Brooklyn Inland Wetlands Commission
Special Meeting Agenda
Tuesday, August 8, 2023
Zoom and In-Person Meeting
Community Center
31 Tiffany Street Upper Level
6:00 p.m.

RE: **Special Permit Modification
Townsend Development Associates, LLC
SP 15-006**

Below is an itemized response to the July 5, 2023 and July 10, 2023 Review Comments received from Northeastern Connecticut Council of Governments. For clarity original comments are in normal text and CHA responses are in **Bold**.

July 5, 2023 - Engineering Site Plan & Drainage Report Review

UTILITY PLAN

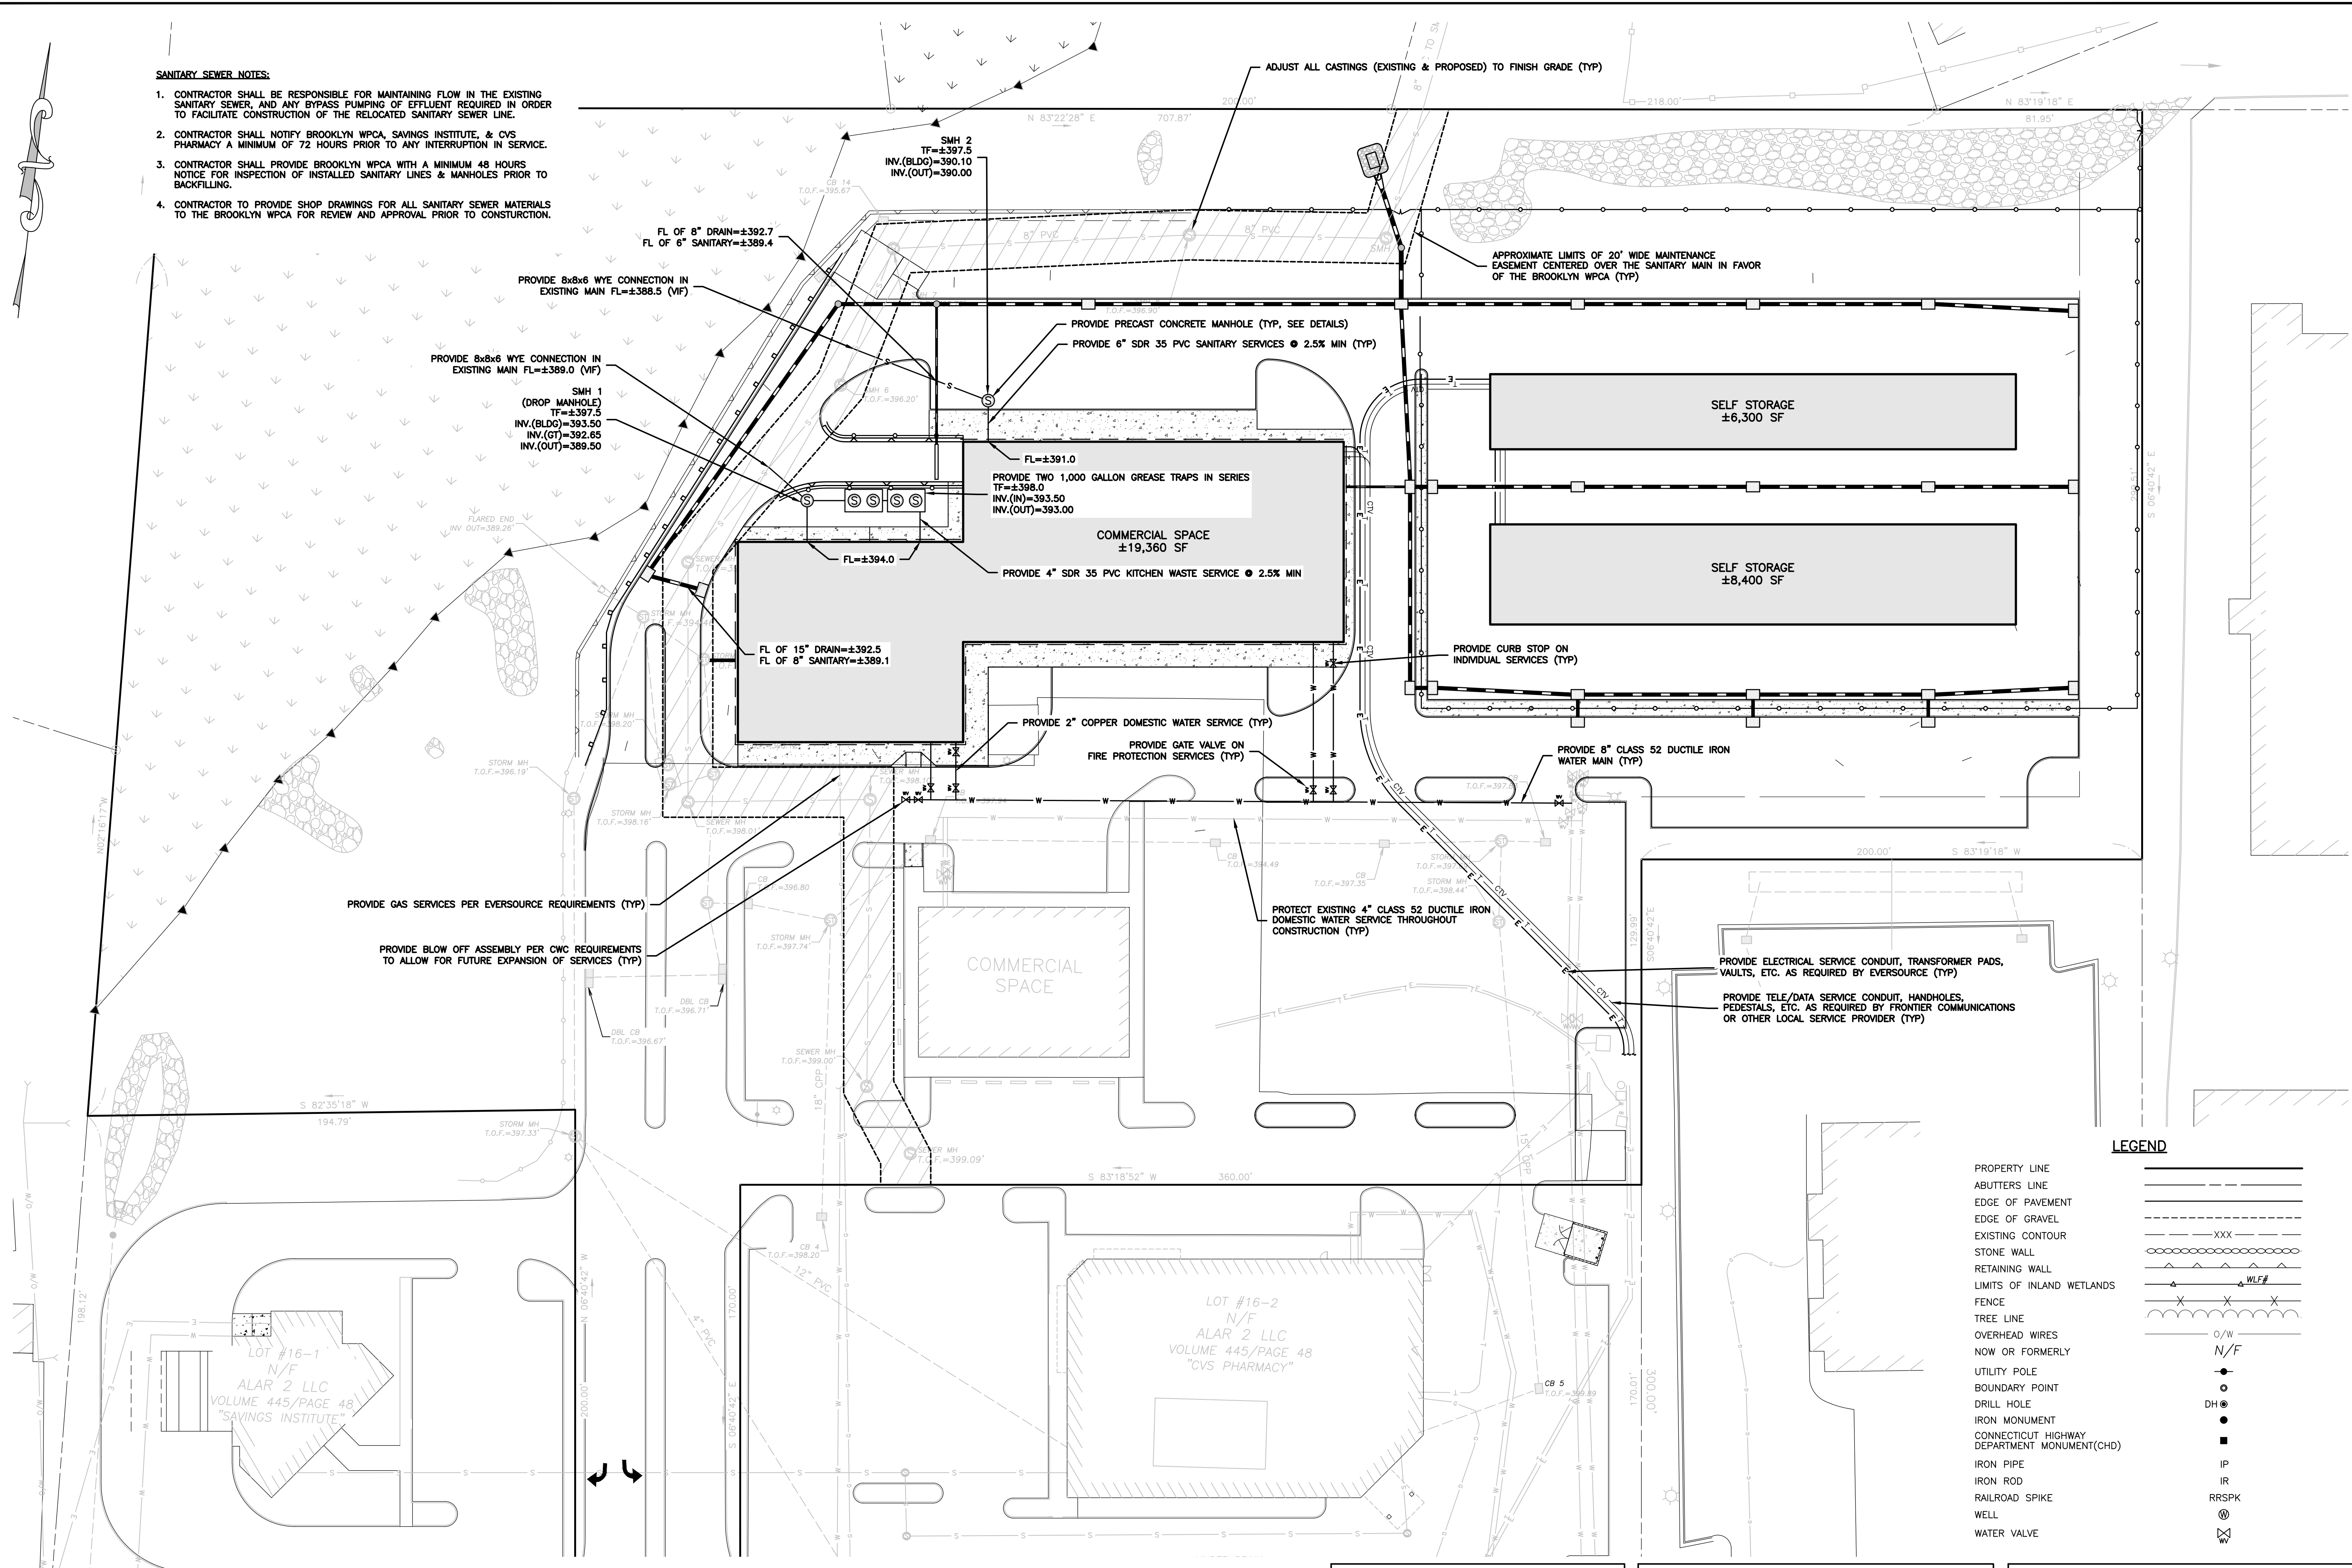
1. For the restaurant operation, it is not evident from the plan where a bulk fat/oil/grease (FOG) recovery tank will be located on the site close to the restaurant. This location needs to be added to the plan in an enclosed area.

2. Who is going to be responsible for the maintenance of certain utilities (water, gas, electric, telephone, cable, etc.) on site? If utility companies will be responsible for maintenance and ownership, are easements necessary for their infrastructure on private property? If so, they need to be shown on the plan similar to the sewer maintenance easement.
